SERIAL: NLS-84-500

BRUNSWICK STEAM ELECTRIC PLANT, UNIT NOS. 1 AND 2
DOCKET NOS. 50-325 & 50-324/LICENSE NOS. DPR-71 & DPR-62
DEMONSTRATION OF CONTAINMENT PURGE AND VENT VALVE OPERABILITY

FIGURE 1

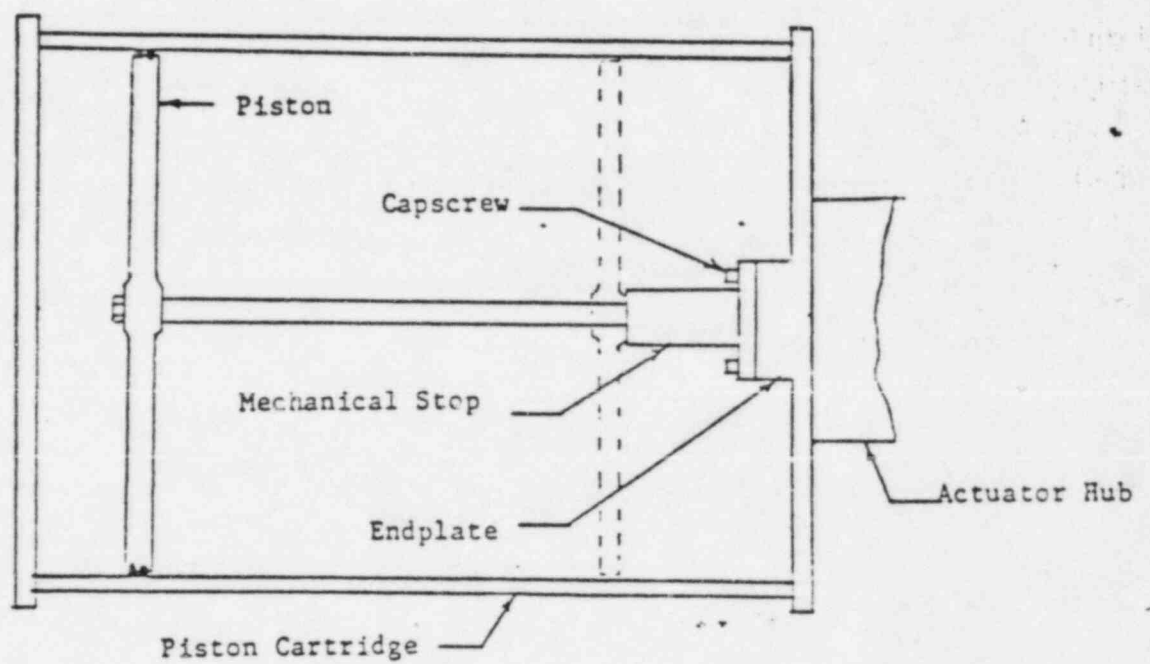
Based on analysis performed by POSI-SEAL International, Inc. (provided by letter dated February 29, 1984), CP&L demonstrated operability of the 4 and 8-inch containment purge and vent valves with no physical restriction on the degree of valve opening. The analysis also determined that the 18, 20, and 24-inch valves will properly function during a combined LOCA and seismic event with the valve opening limited to 50 degrees or less. Though the SER discussed the larger valves, it did not address the study's findings regarding the 4 and 8 inch valves. We request that the SER be revised to permit re-energizing the 4-inch valves and removal of the mechanical limits on the 8-inch valve.

Mechanical Stop
for
Restricting Valve Opening

Based on the above discussion, Carolina Power & Light Company requests that the SER issued September 18, 1984 be revised to permit re-energizing the 4-inch valves (CAC-V49 and CAC-V50) and to allow removal of the mechanical limit on the 8-inch valve (CAC-V4). Also, the Company commits to reflect the limitation of opening angle for the 18, 20, and 24-inch containment purge and vent valves in the next amendment to the Brunswick Updated FSAR in lieu of submitting a technical specification amendment request.
